## Town of East Hampton – Planning

<b>Name: East Hampton Energy Storage Center LLC</b>
<b>Tax Map Number: 300-185-2-2</b>
<b>Description: Site Plan Special Permit</b>
<b>Box: 72</b>

**Subject: Site Plan/Special Permit Application for the  
 East Hampton Energy Storage Center, LLC  
 SCTM #300-185-2-2  
 3 Cove Hollow Road  
 East Hampton, New York**

**Figure 4 of Project Narrative – Updated:**

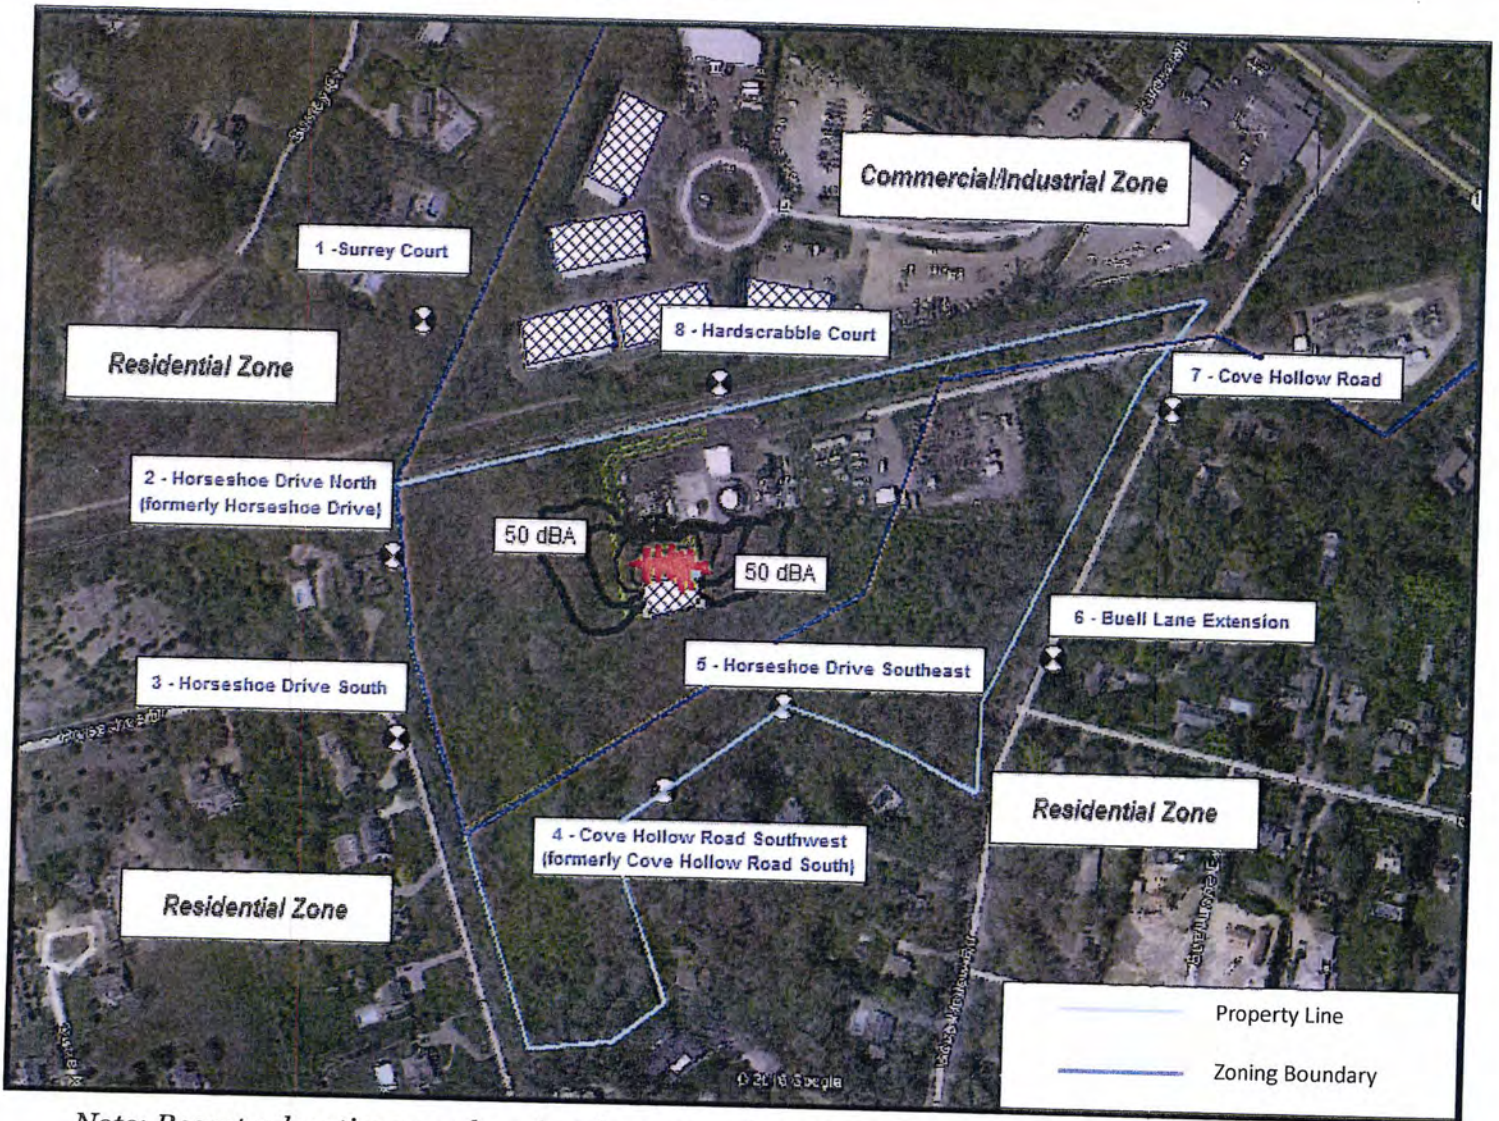
- Figure 4 depicts two locations on Horseshoe Drive and four on Cove Hollow Road that appear to have been analyzed for noise levels. Table 4 only provides data for two locations and it is not clear which of the six locations this data represents. Residents from these areas may be concerned over the potential noise, and it is recommended that the applicant provide the data from all of the locations analyzed.

Planning Board 1/12/2017 Comment: Additional information concerning noise levels, including the analysis of decibel levels at all six locations indicated on Figure 4...should be submitted.

The noise modeling analysis has been revised since the original submittal. As requested in the Planning Board's letter dated January 12, 2017, Table 4 of the Project Narrative has been updated to show the calculated sound levels for all eight of the noise model locations. The model receptors have also been moved to the individual property line locations in order to compare the results to the East Hampton noise ordinance limits. Figure 4 of the Project Narrative has also been updated to depict each modeling property line location by name and number. The updated Table 4 and updated Figure 4 are provided in Attachment B of this letter and compliance with the Town's noise ordinance has been demonstrated.

**NOISE CONTOUR MAP**

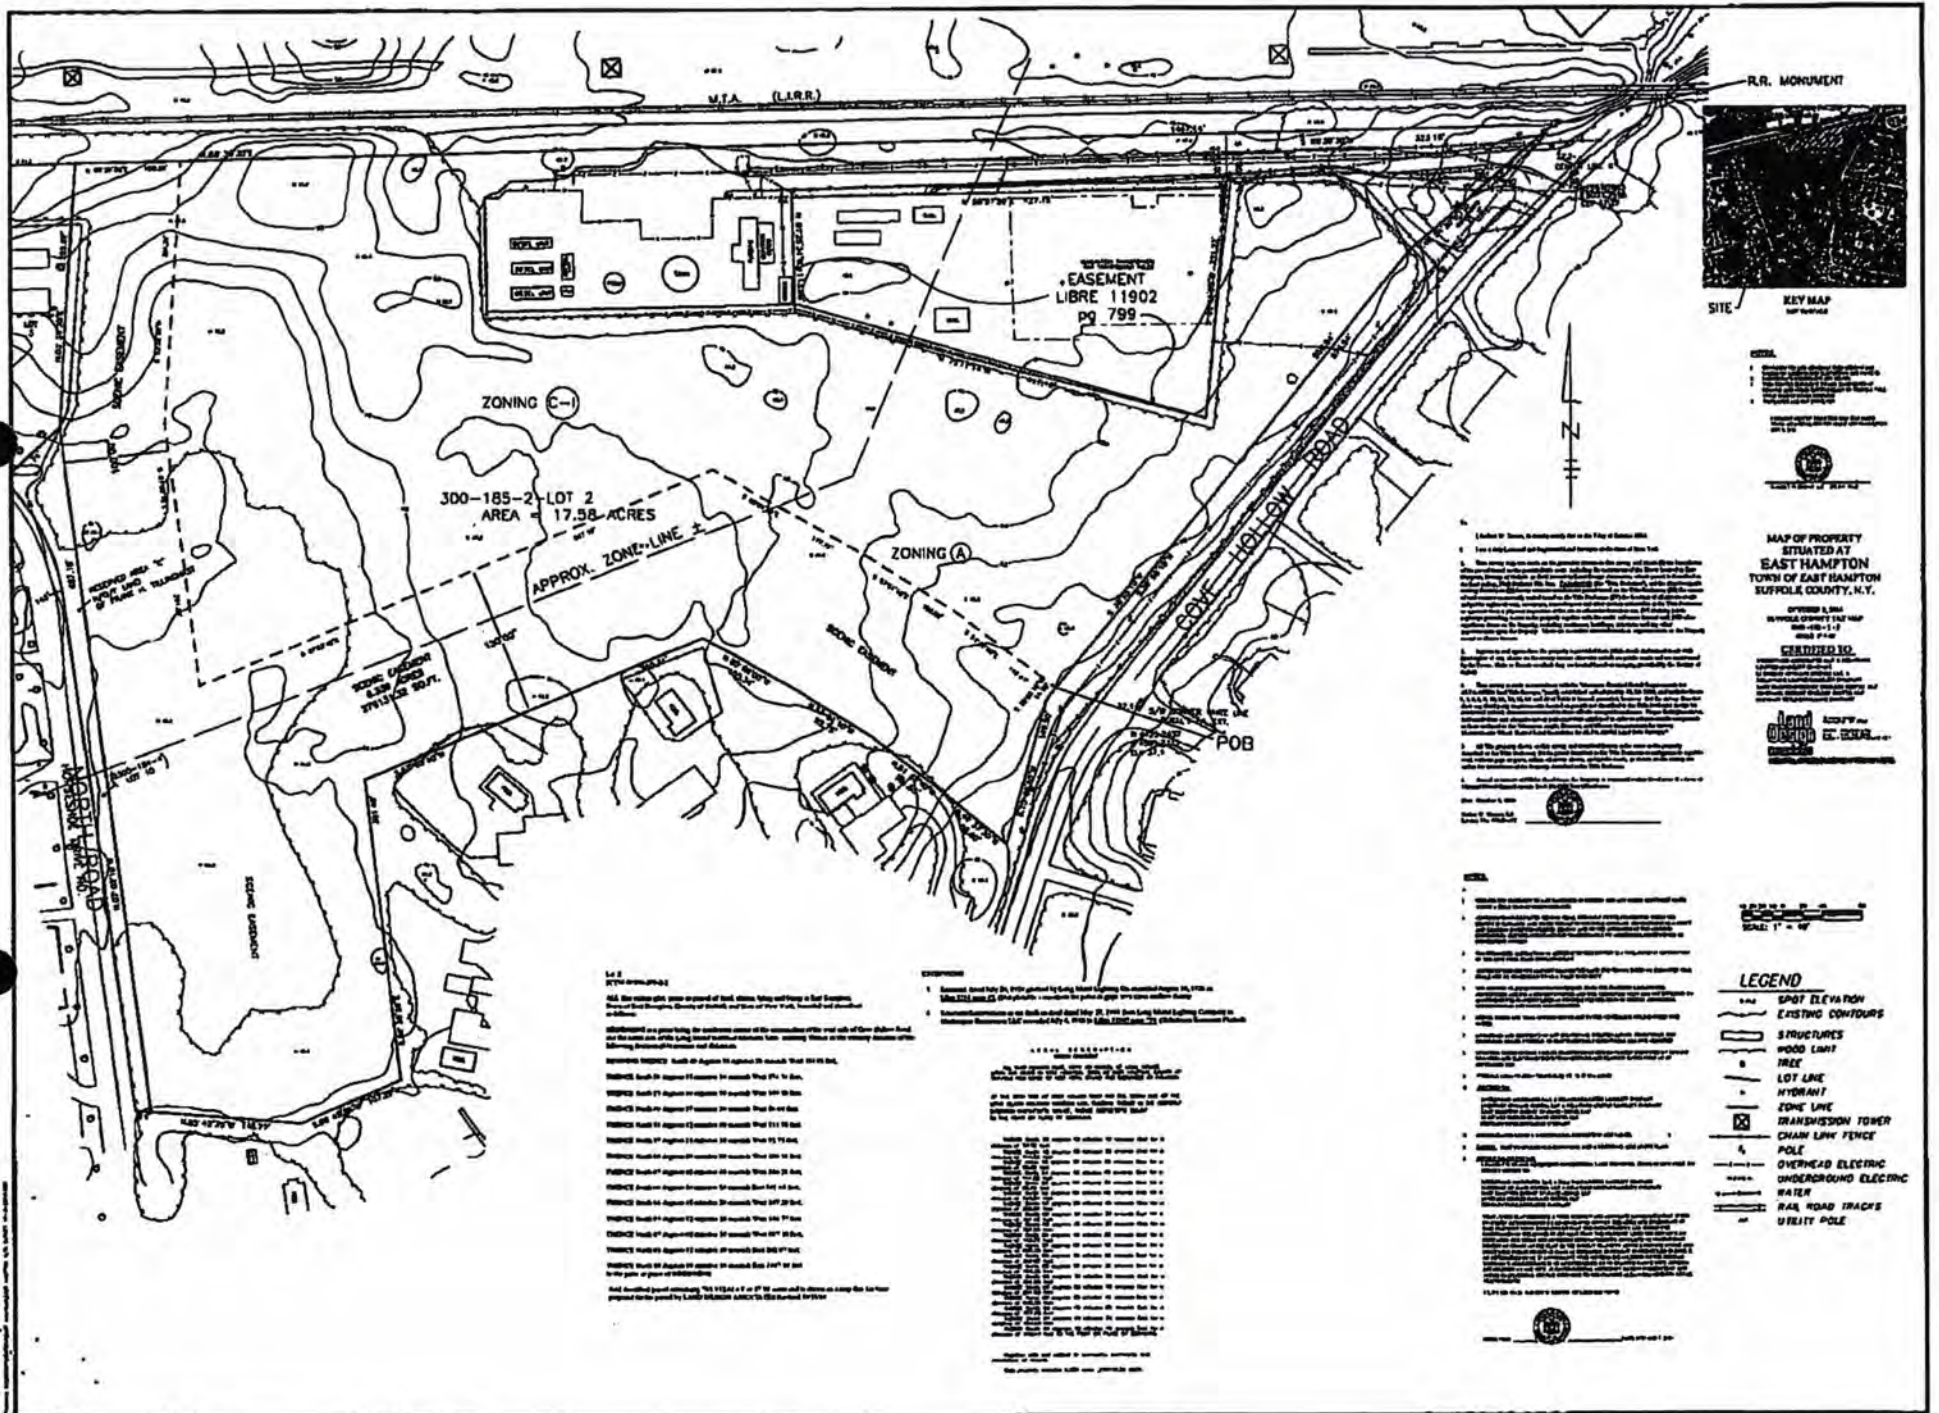
The narrative states that three noise receptor locations were analyzed: one each on Horseshoe Drive and Cove Hollow Road in residential zoning districts and one to the north on Hardscrabble Court. Figure 4 indicates that areas where the project noise will be at 50 dBA and 55 dBA, both within limits permitted under the Town Code, fall within the site and therefore noise levels will not exceed restrictions in the Town Code.
